ADDENDUM NO.1 - Mercedes Sports Park – Phase 1

DATE: Tuesday, December 11, 2018

JOB No. 2017-019

EX. OUTDOOR EXERCISE EQUIPMENT
SIDEWALK INTERSECTION JOINTS. SEE DETAIL (6/L4)

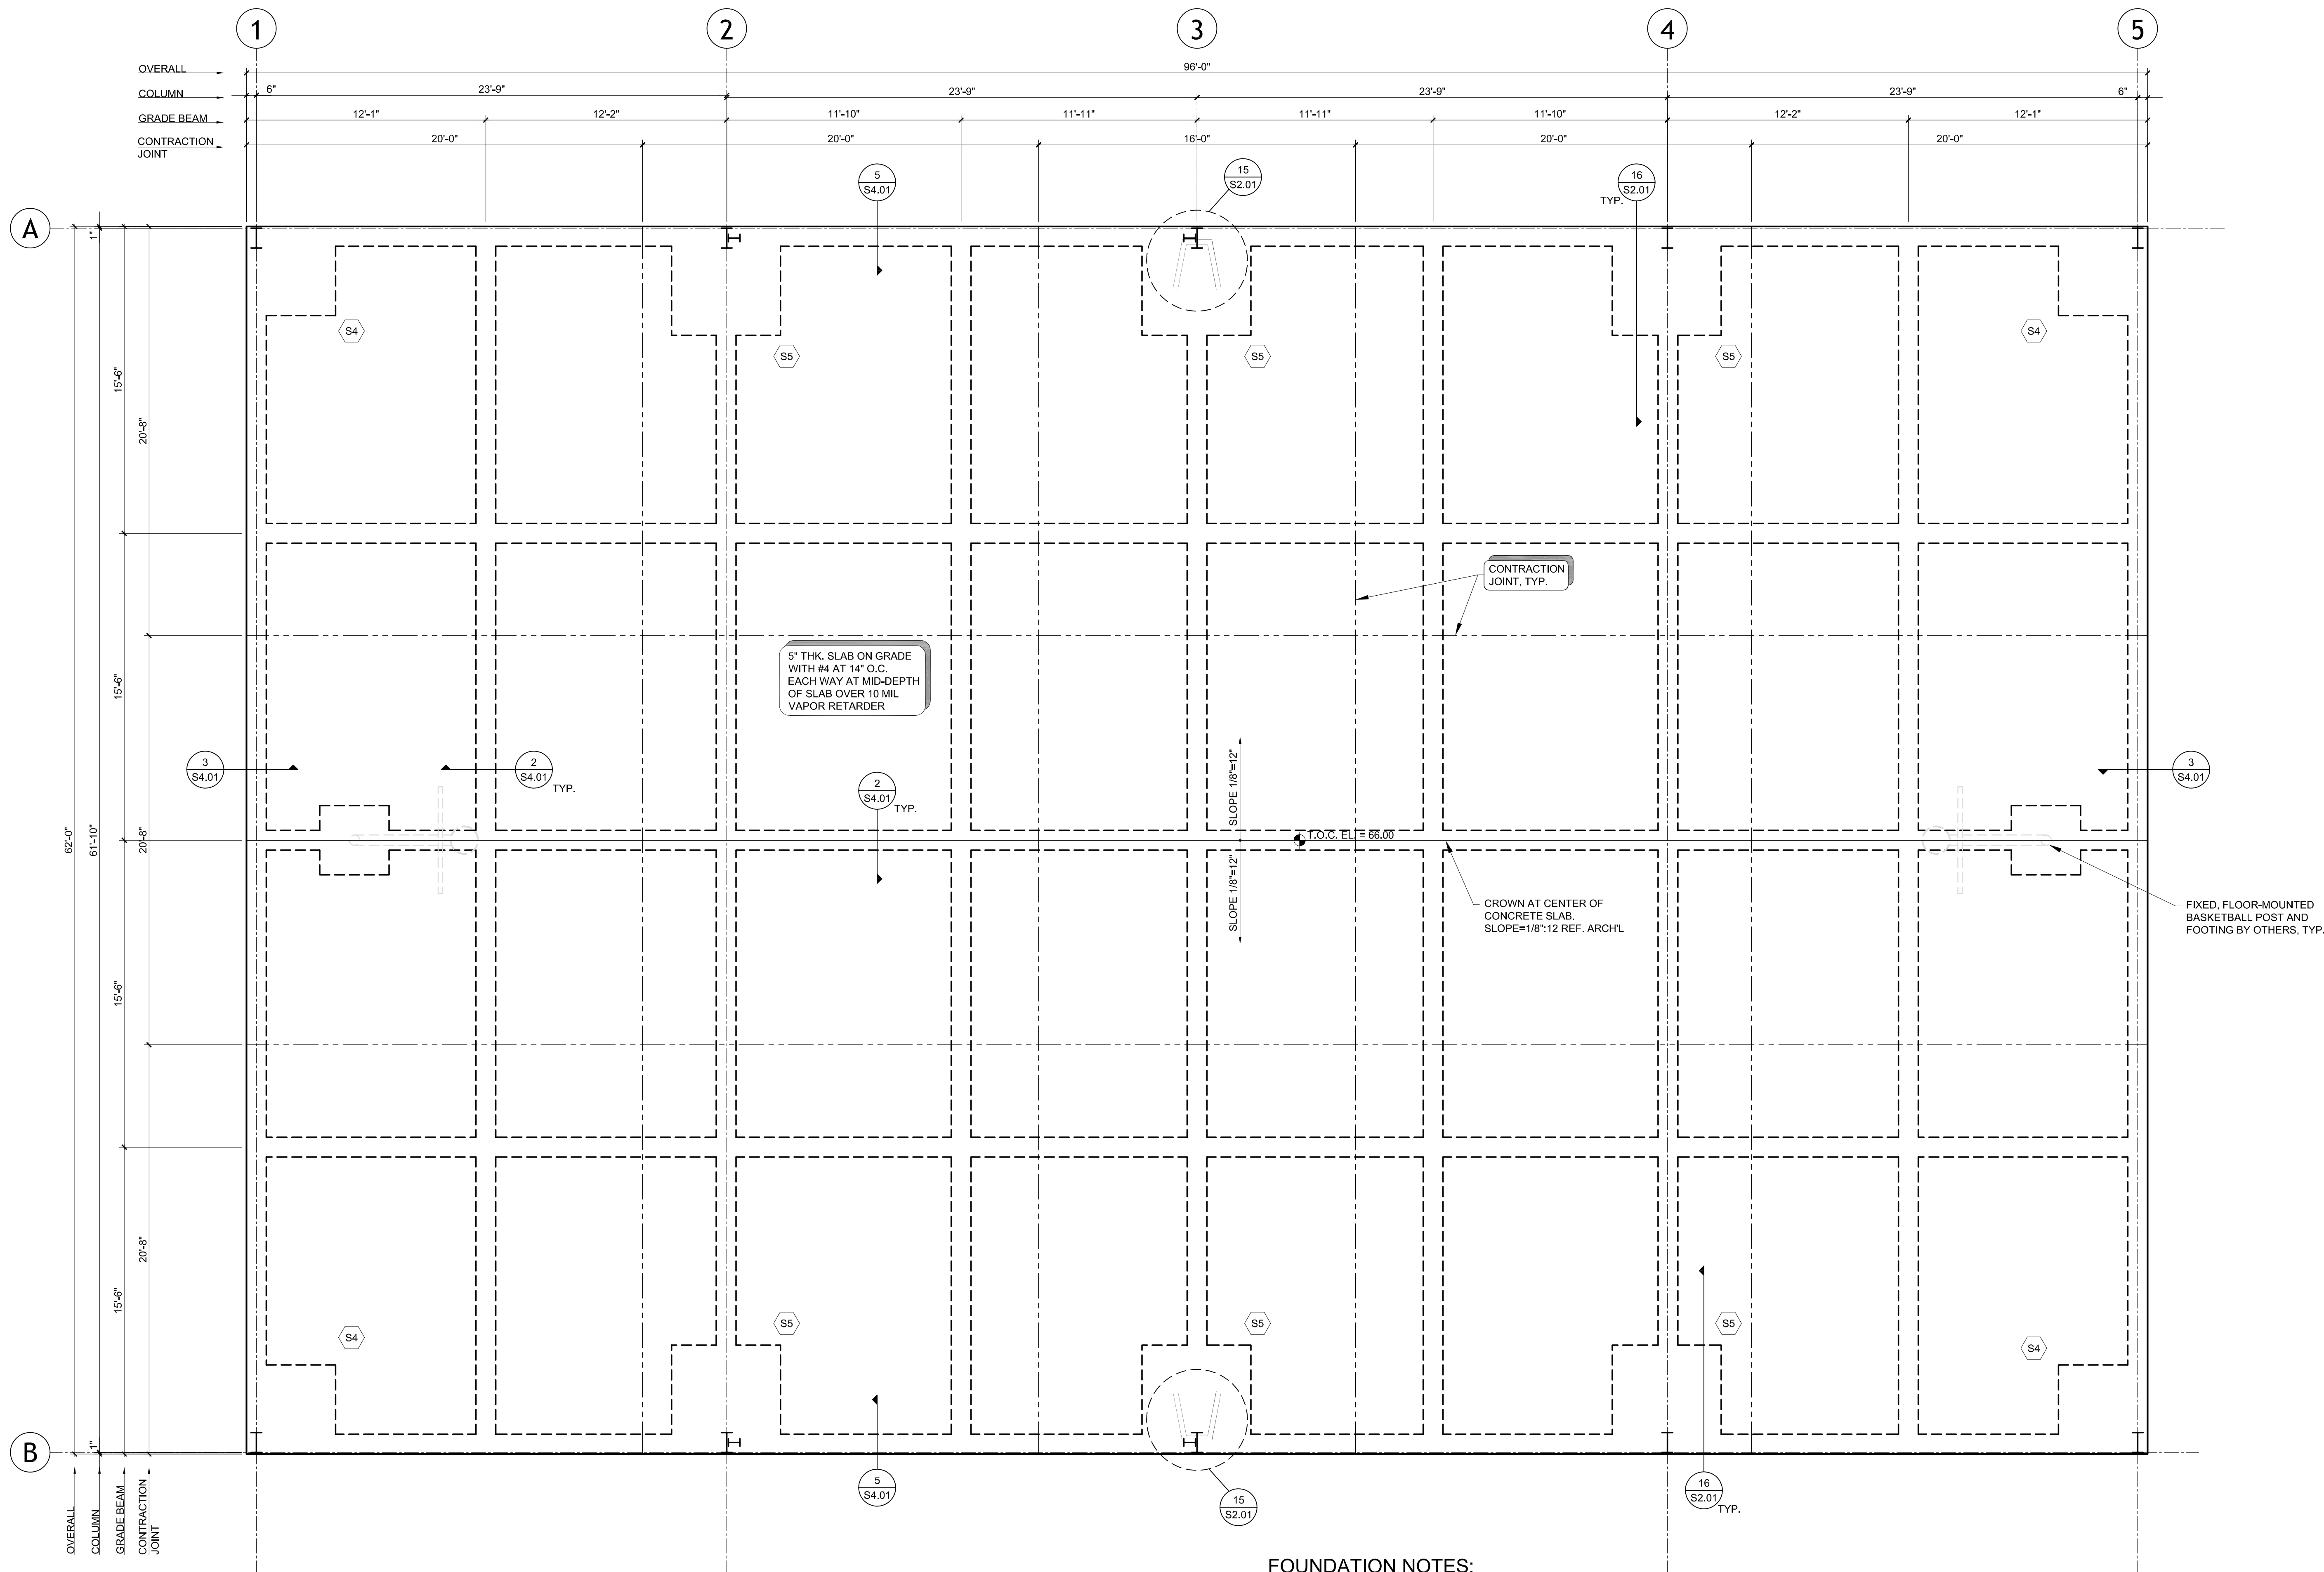
- A. See attached Landscape Addendum items. (12-8.5x11), (2-24"x36")
Sheet L2: Added a note for sidewalk intersections, this note will refer you to detail 6/L4.
Sheet L4: Added sidewalk intersection layout detail for control/expansion joints to reduce concrete cracking.
Per attached, add Specification Section 328400 NON-Potable Planting Irrigation. This Spec Section is for the harvesting tank irrigation system use only.

S3.03

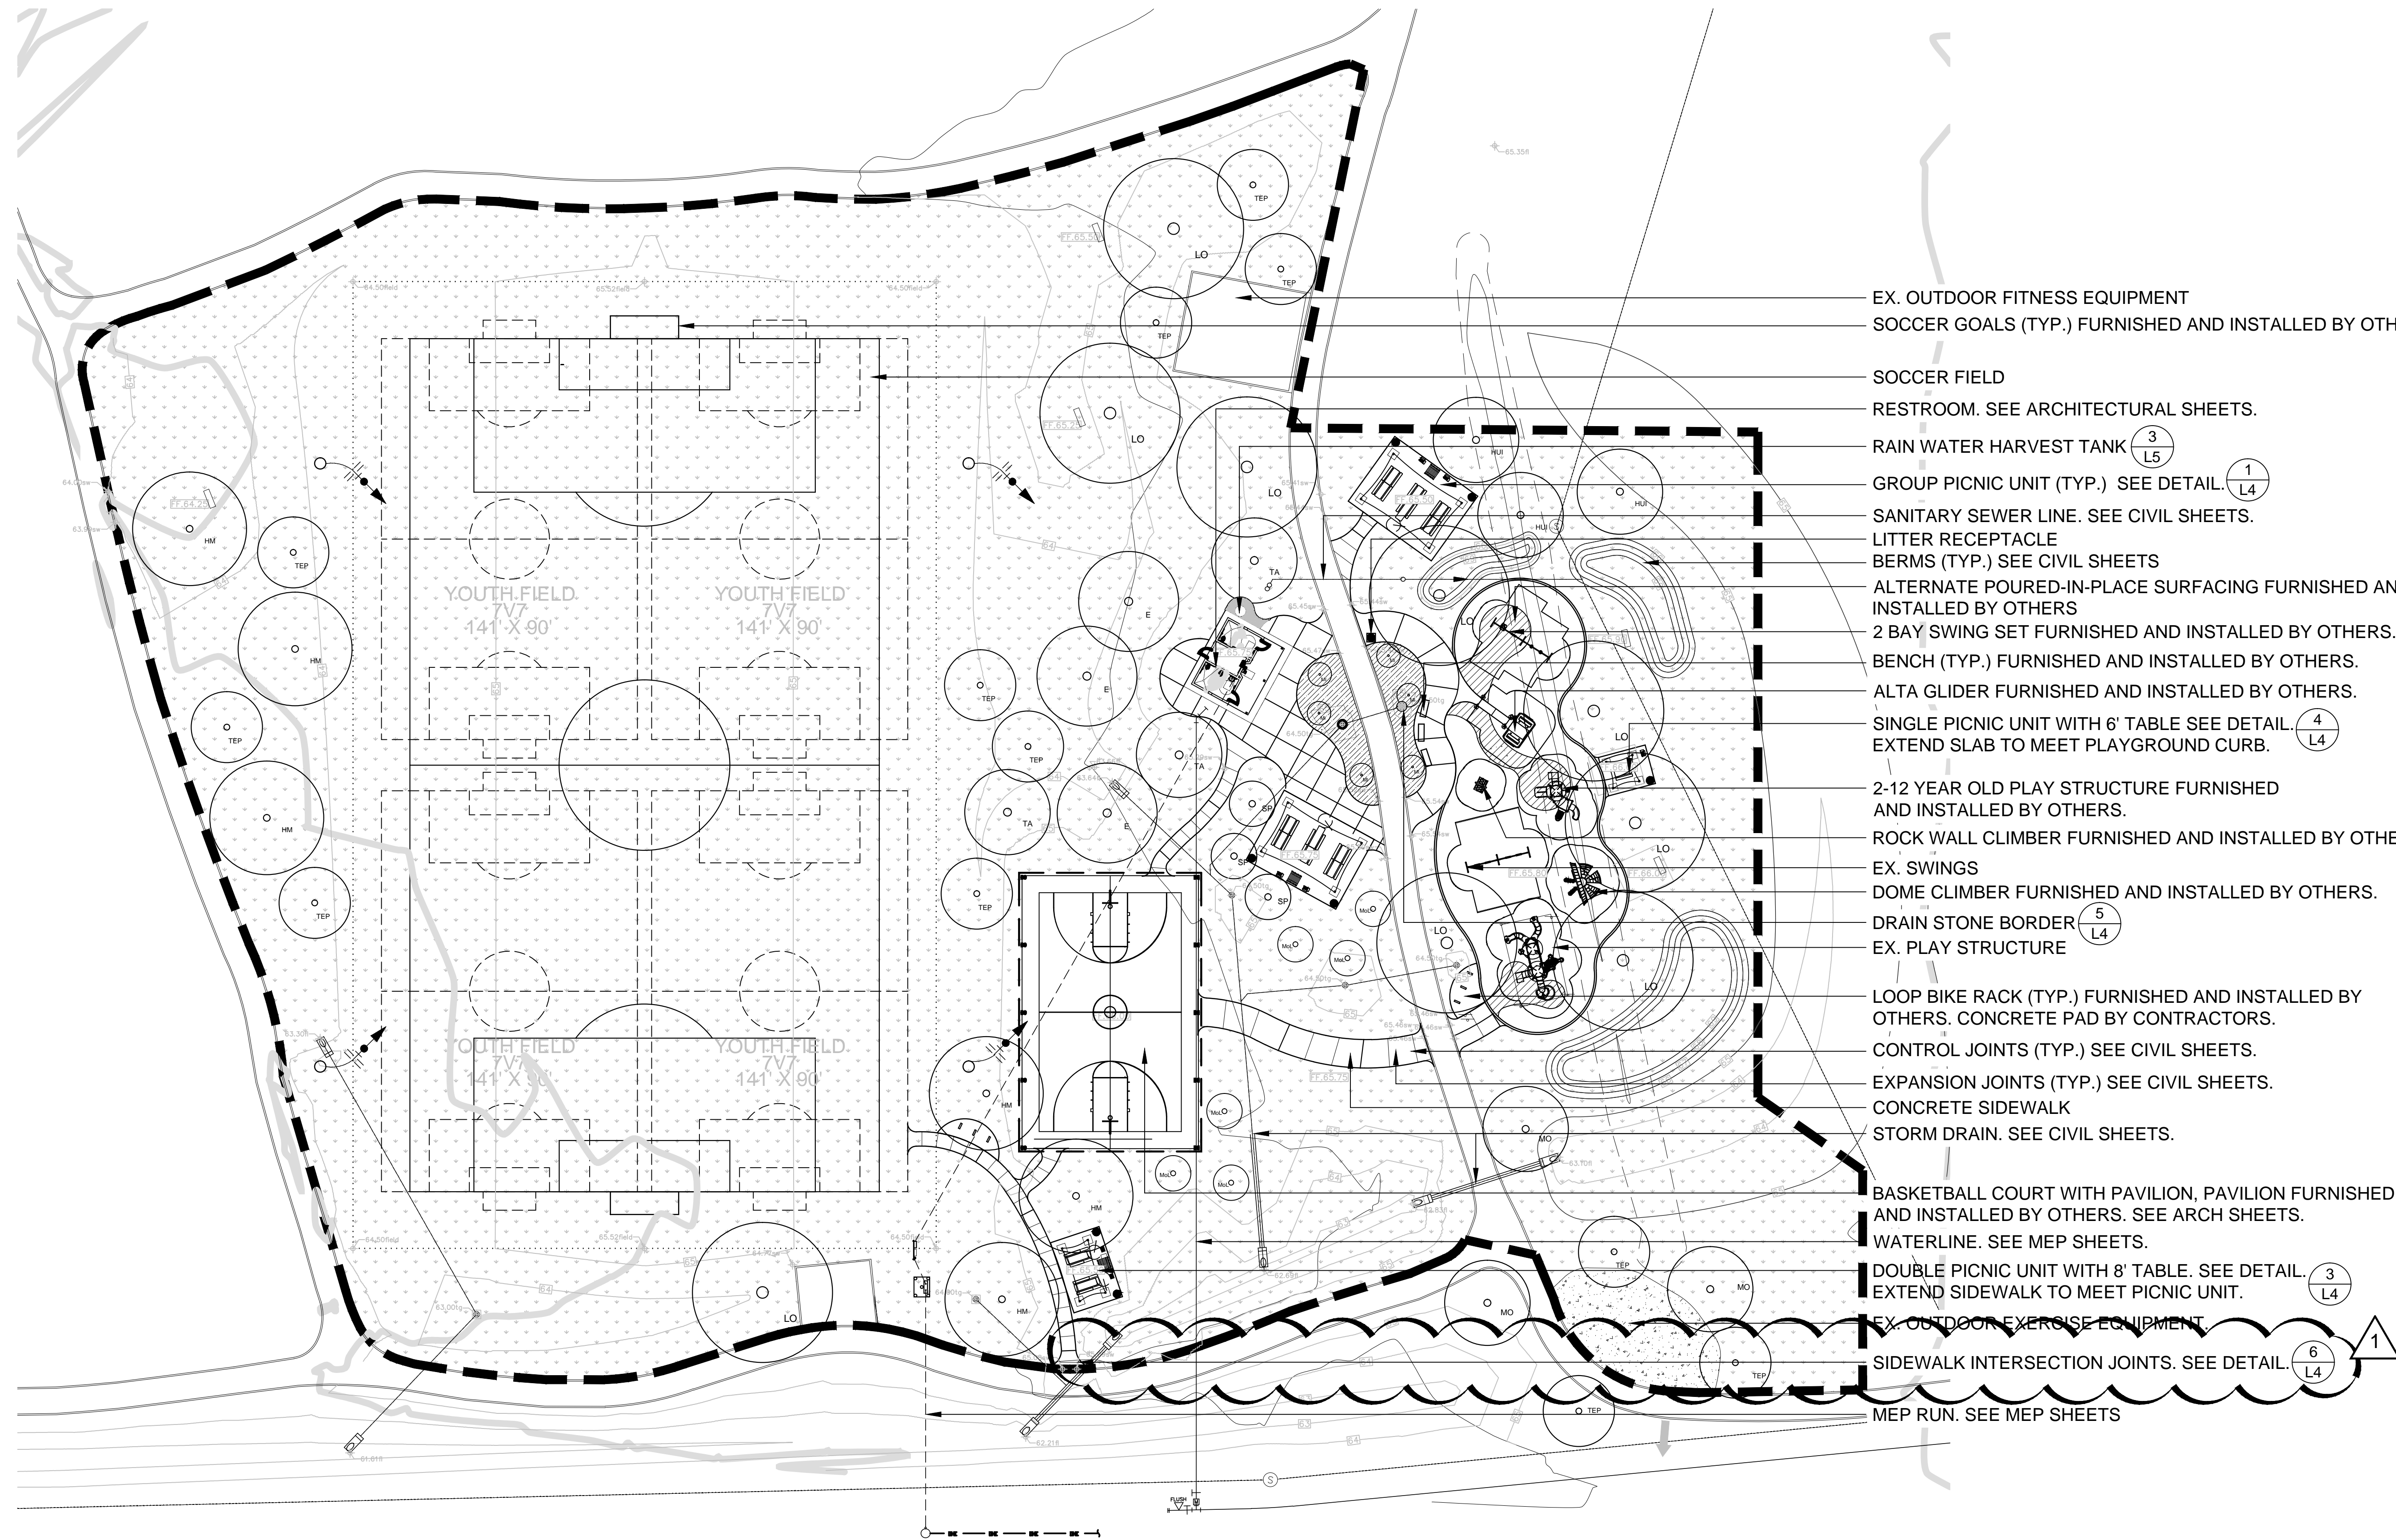
- A. See attached Structural addendum items. (1-24"x36")
Sheet S3.03: Note new contraction joints were added.
